**NELSON GEOTECHNICAL
ASSOCIATES, INC.**

Critical Areas Study and Geotechnical Plan Review
Moran Residence Development
5000 West Mercer Way
Mercer Island, Washington
NGA File No. 1211520

PLAN REVIEW

Photographic Documentation of Critical Areas

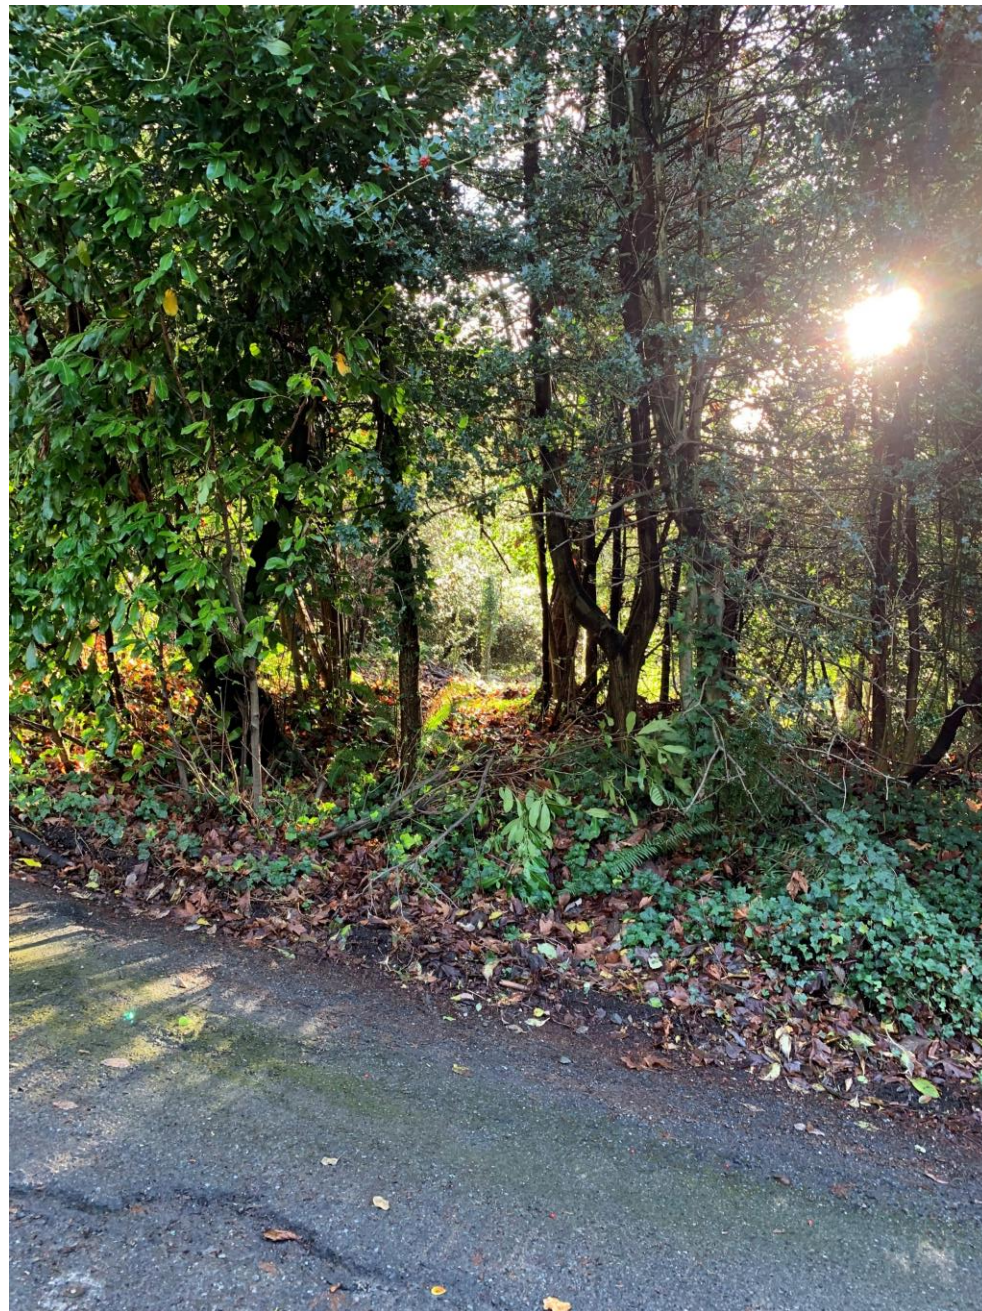
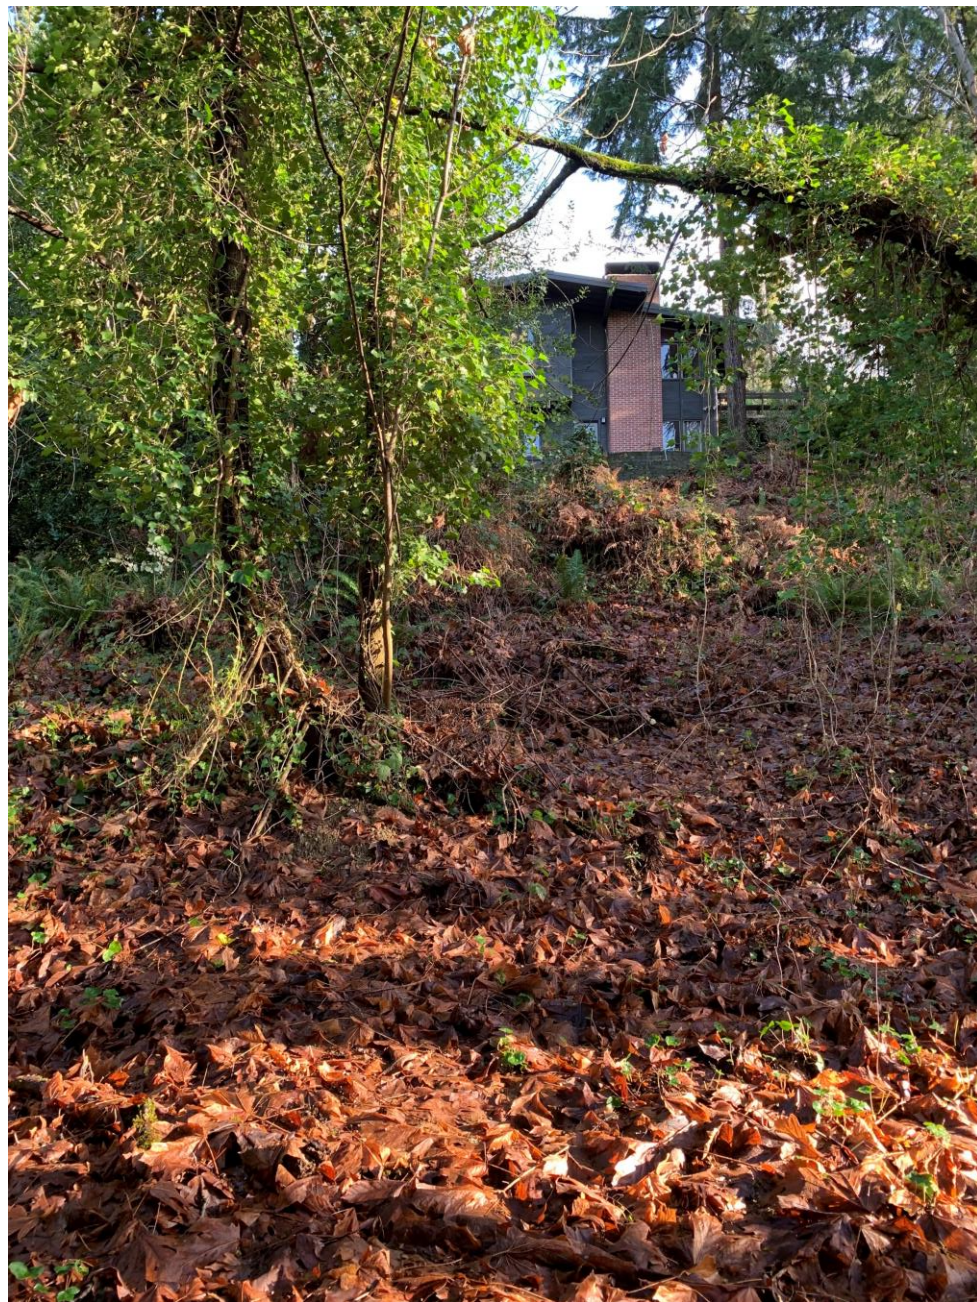
We understand the proposed single-family residence will be situated within the central portion of the site on a gently sloping bench area bound by moderate to steep west-facing slopes to the east and west. The upper steep slopes generally descend from the eastern property line at gradients in the range of 18 to 33 degrees (32.5 to 64.9 percent) down to the upper portion of the gently sloping bench area, while the lower western steep slopes descend from the planned building area at gradients in the range of 20 to 45 degrees (36.4 to 100 percent). The overall vertical relief of the upper eastern steep slopes is approximately 30 to 35 feet while the lower western frontage steep slopes provide approximately 10 to 16 feet of relief. The gently sloping bench and planned development area spans approximately 45 to 65 feet in width from east to west and provides approximately 5 to 10 feet of relief. Existing slope conditions were documented in photographs which are presented as **Appendix A** of this letter.

TOPOGRAPHIC & BOUNDARY SURVEY

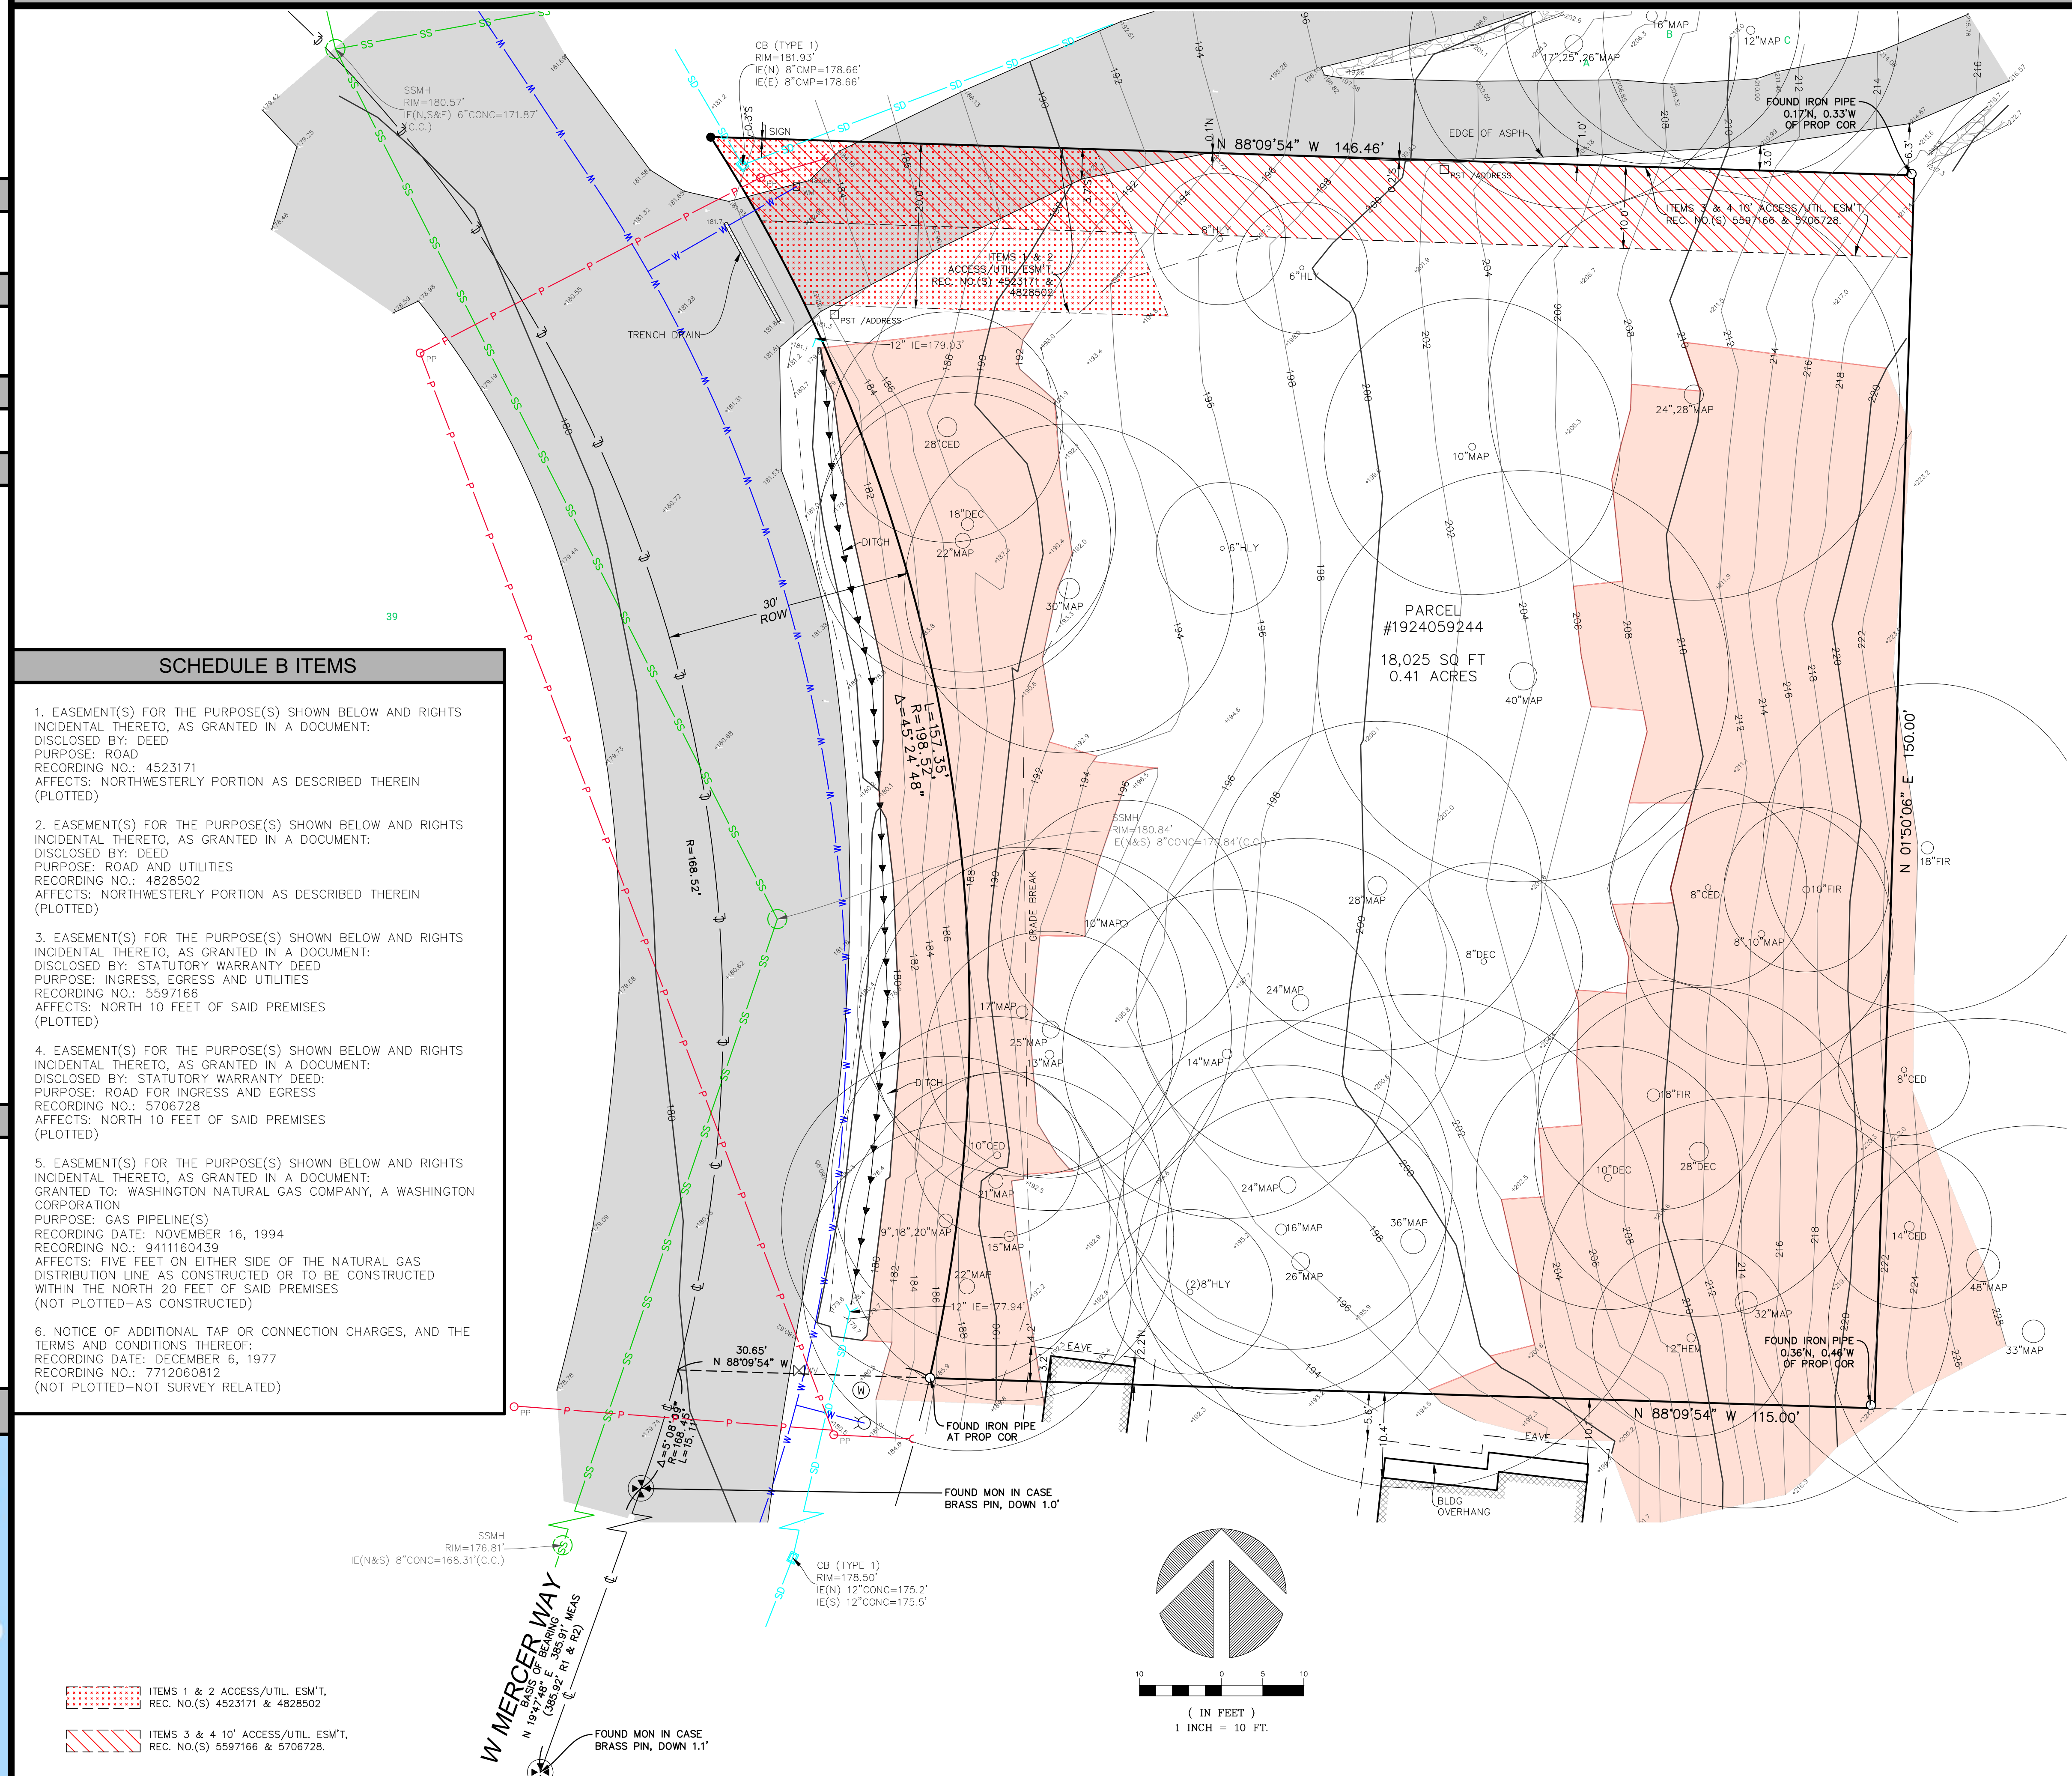
In accordance with MIMC 19.07.160(C)(2)(b), shallow landslide hazard areas include 25-foot buffers in all directions. The location of the designated Landslide Hazard Area in proximity to the site is shown on the Topographic and Boundary Survey attached in **Appendix B**. The proposed residence will be located as close as 13 feet from the toe and 6 feet from the top of Landslide Hazard Areas within the site and will therefore intersect and overlap the 25-foot Landslide Hazard Area buffers as shown on an excerpt from the Civil Engineering Plan Set in **Appendix C**, which also presents a scale map of the proposed project.

Methodologies for designation of the critical areas and associated buffers are presented on the Topographic and Boundary Survey. Furthermore, land clearing, grading, filling, and foundation work within landslide hazard areas are not permitted between October 1 and April 1. Slope stability concerns controlled effectively with Best Management Practices may waive this prohibition. We review Temporary Erosion and Sediment Control (TESC) plans for the project in the **PLAN REVIEW** subsection of this letter.
